SUBJECT: Forwards responses to NRC comments on 860822 ltr. No credit taken for neoprene gaskets on watertight or tornado proof doors during fires. Simultaneous fires & tornadoes not postulated.

Re: Nine Mile Point Unit 2
Docket No. 50-410

RESPONSES TO NRC STAFF COMMENTS

REF : DRS SA240-1
 R240-2
 R240-3
 FIG: 9A-3-18

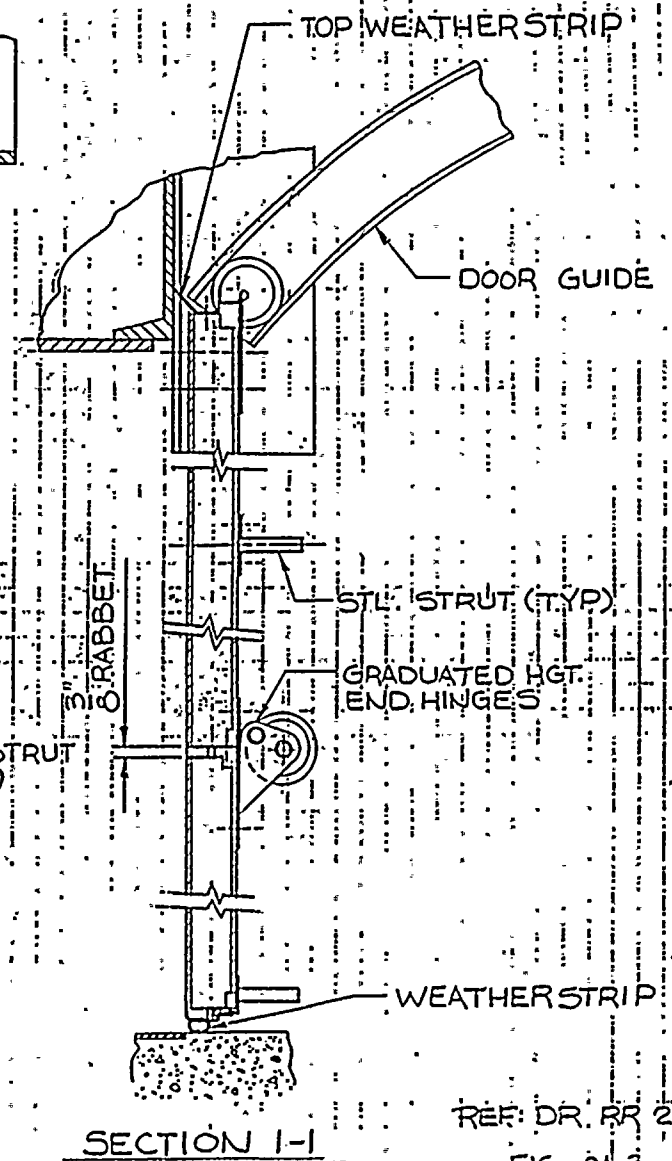
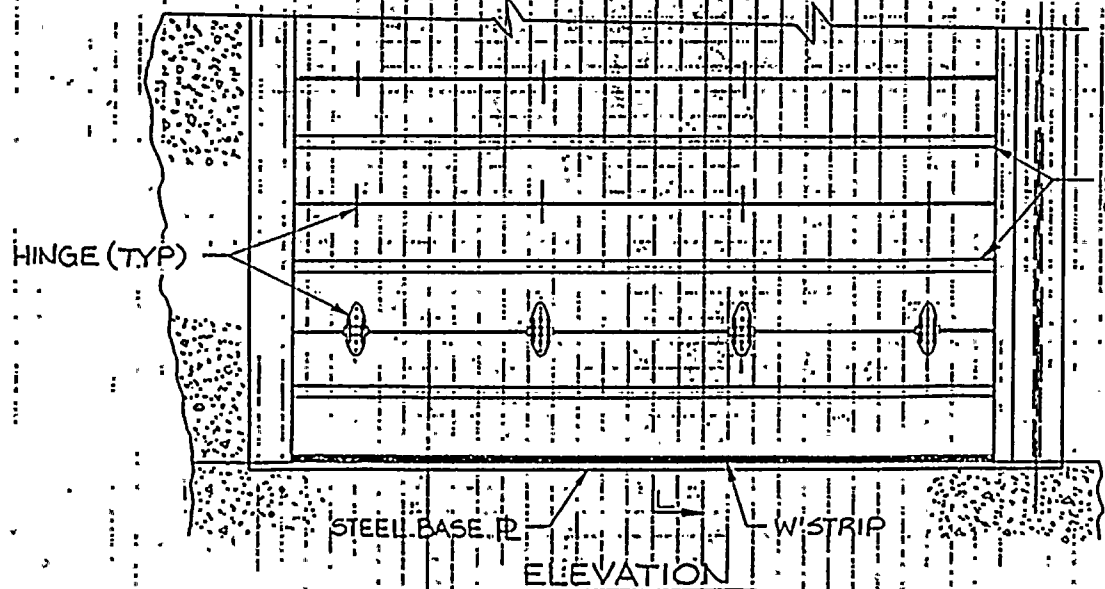
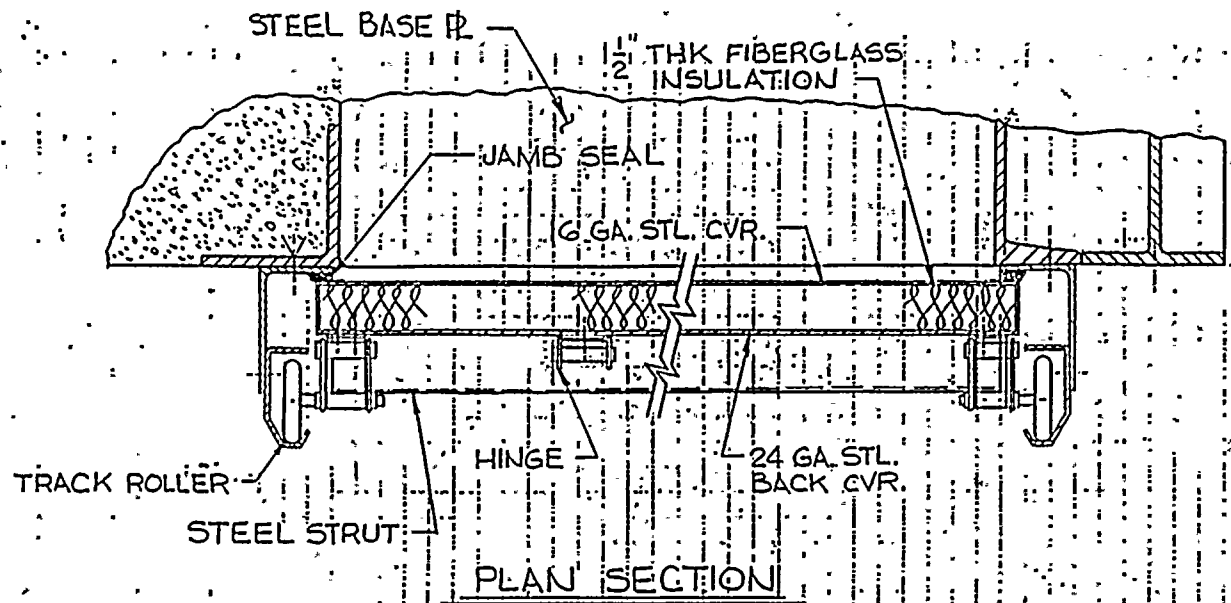
QUESTION 1: Where are Figures 9A.3-18 through 9A3-22?

RESPONSE 1: These figures were inadvertently left out of the August 22, 1986 submittal. They are enclosed.

FIG. 9A.3-21

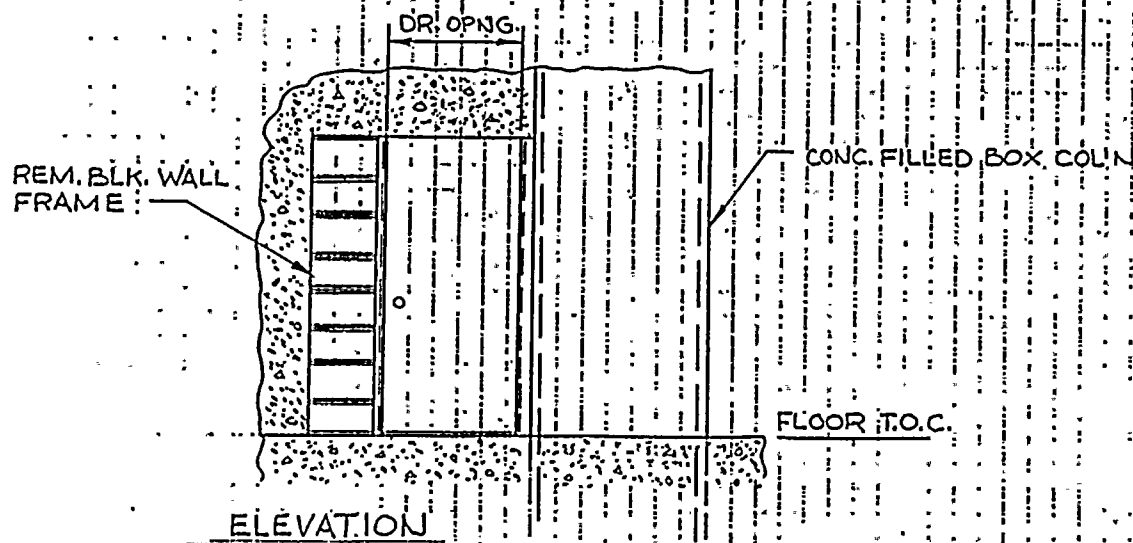
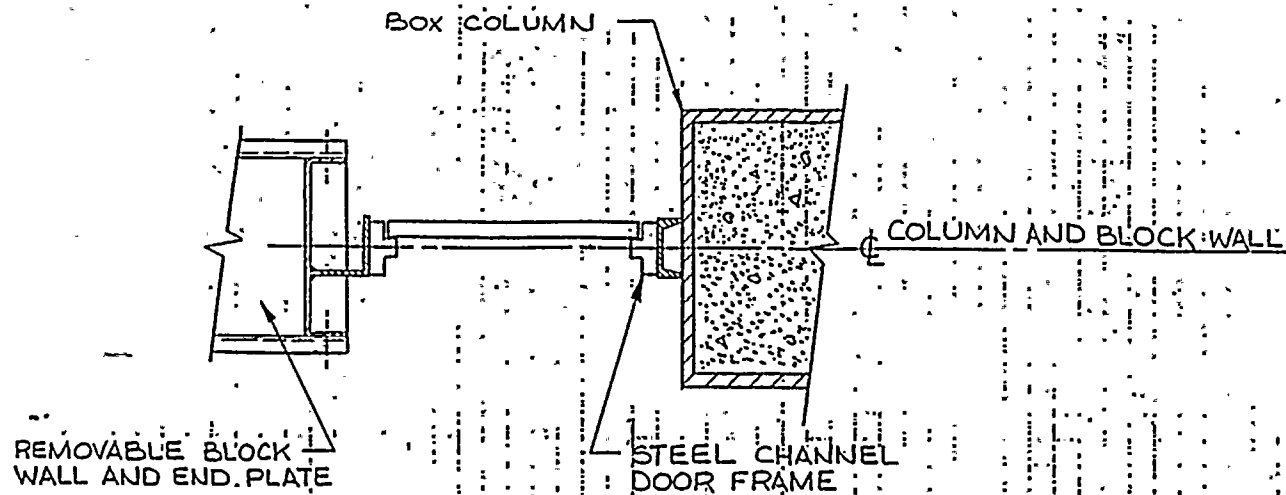
QUESTION 2: Relative to the page 9A.3-42 change, are there two doors or three doors which are being discussed?

RESPONSE 2: There are TWO doors. See the attached FSAR change.

TWO DOORS, R289-9, SW261-10 ARE U.L. FIRE RATED DOORS. HOWEVER DUE TO OTHER DESIGN CONSIDERATIONS THE INSTALLATION DOES NOT MEET U.L. STANDARDS. FIGURES 9A.3-21 AND 9A.3-22 SHOW
Nine Mile Point Unit 2 FSAR
INSTALLATION DETAILS FOR THESE DOORS.
